Form 3160-3 (June 2015)					APPROV o. 1004-0 inuary 31,	137
UNITED STATES DEPARTMENT OF THE INT BUREAU OF LAND MANAG	5. Lease Serial No. NMNM078968A					
APPLICATION FOR PERMIT TO DRI		6. If Indian, Allotee	or Tribe 1	Name		
1a. Type of work: Image: Constraint of the second seco	NTER			7. If Unit or CA Agr	eement, N	Name and No.
1b. Type of Well: ✓ ✓ Oil Well Gas Well		8. Lease Name and	Well No.			
1c. Type of Completion: ☐ Hydraulic Fracturing ✔ Single			0 FED C

PECOS DISTRICT DRILLING CONDITIONS OF APPROVAL

OPERATOR'S NAME:	EOG RESOURCES INCORPORATED
WELL NAME & NO.:	PRETTY GOOD 20 FED COM 709H
SURFACE HOLE FOOTAGE:	215'/N & 1684/W
BOTTOM HOLE FOOTAGE	100'/S & 830'/W
SURFACE LOCATION:	Section 20, T.22 S., R.32 E., NMP
COUNTY:	Lea County, New Mexico

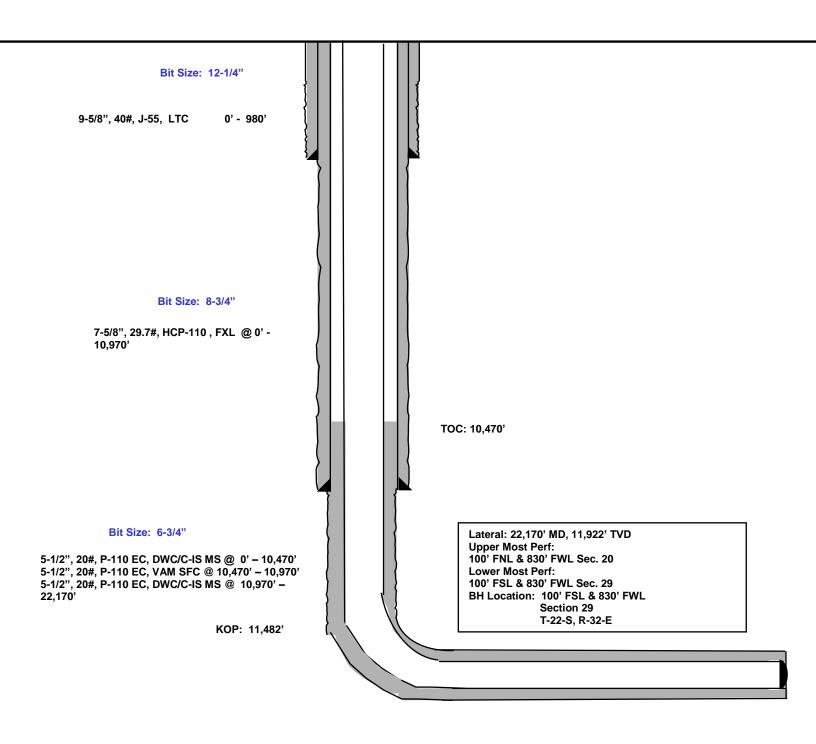
After running the 9-5/8" surface casing, a 9-5/8" BOP/BOPE system with a minimum working pressure of 10,000 psi will be installed on the wellhead system and will be pressure tested to 250 psi low followed by a 10,000 psi pressure test. This pressure test will be repeated at least every 30 days, as per Onshore Order No. 2

The multi-bowl wellhead will be installed by vendor's representative(s). A copy of the installation instructions for the Cactus Multi-Bowl WH system has been sent to the NM BLM office in Carlsbad, NM.

The wellhead will be installed by a third party welder while being monitored by WH vendor's representative.

All BOP equipment will be tested utilizing a conventional test plug. Not a cup or J-packer type. EOG Resources reserves the option to conduct BOPE testing during wait on cement periods provided a test plug is utilized.

A solid steel body pack-off will be utilized after running and cementing the intermediate casing. After installation the pack-off and lower flange will be pressure tested to 5000 psi.

- 2. Operator has proposed a multi-bowl wellhead assembly. This assembly will be tested when installed on the surface casing. Minimum working pressure of the blowout preventer (BOP) and related equipment (BOPE) required for drilling below the surface casing shoe shall be 10,000 (10M) psi. Variance is granted to use a 10,000 psi BOP with a 5,000-psi annular preventer. Before drilling out of the surface casing, the ram-type BOP and accessory equipment shall be tested to 10,000/250 psi and the annular preventer to 5,000/250 psi.

- a. Wellhead shall be installed by manufacturer's representatives, submit documentation with subsequent sundry.
 - b. If the welding is performed by a third party, the manufacturer's representative shall monitor the temperature to verify that it does not exceed the maximum temperature of the seal.

- c. Manufacturer representative shall install the test plug for the initial BOP test.
 - d. If the cement does not circulate and one-inch operations would have been possible with a standard wellhead, the well head shall be cut off, cementing operations performed and another wellhead installed.
